1. Authors answers to comments by referee # 1

2. Answers to comments by reviewer #2

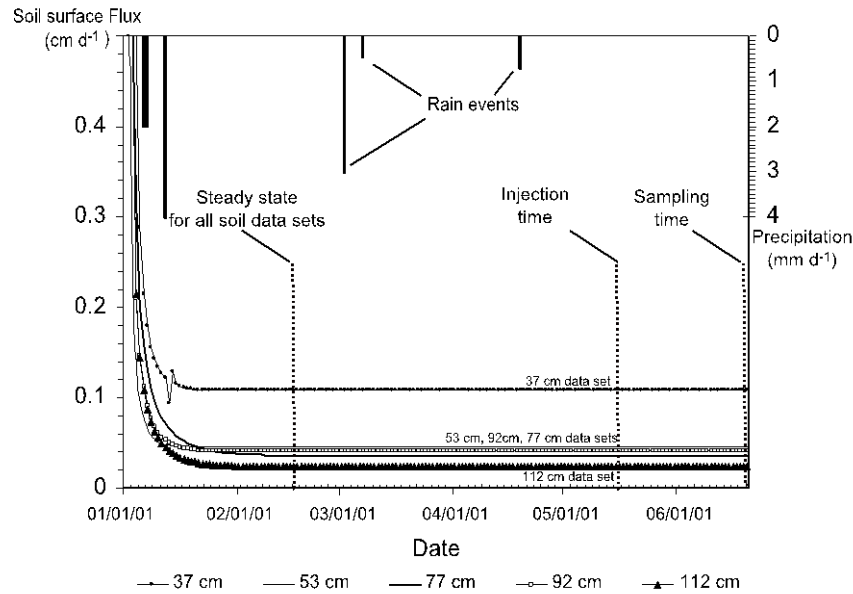
Reviewer #2 The authors do not convince the reader that the system was at steady state over the course of the experiment nor do they provide an assessment of the impact on the results if the steady-state assumption was violated.

Authors answers : Steady state is a working hypothesis in an intent to obtain a range of rates from computation and simulation (using laboratory characterization of hydrodynamic parameters on undisturbed samples) that we would like to compare to peak displacement value obtained by the field experiment (that doesn't require such hypothesis). With the presence of a shallow aquifer, dry soils in arid lands (like under South Moroccan climate) tend to reach the so call a steady state of evaporation at the end of dry season. Authors acknowledge that absolute steady state will never be totally reached in natural conditions (i.e. after an infinite lag time). Nevertheless, site and time were specially selected to near this ideal situation (Long dryness, sandy cover, unexploited aquifer). To convince the reader that our field conditions were the closer possible to this working hypothesis

- 1) We performed simulations with Hydrus using laboratory measured van Genuchten parameters sets : Assuming*
 - a. Initial condition of a saturated profile from 50 cm to 2.44 m. at the beginning of the year 2001.*
 - b. Lower boundary conditions of aquifer level at 2.44 m depth.*
 - c. Upper boundary value of 0.0495%. Water content at 50 cm depth. assuming ET and Rainfall events measured at Agadir Meteo station*
 - d. What ever was the soil parameter data set introduced in the model, permanent steady state is installed in no more than 50 days after saturation. (Injection is performed the 135th days of the year) (see following graph for illustration)*
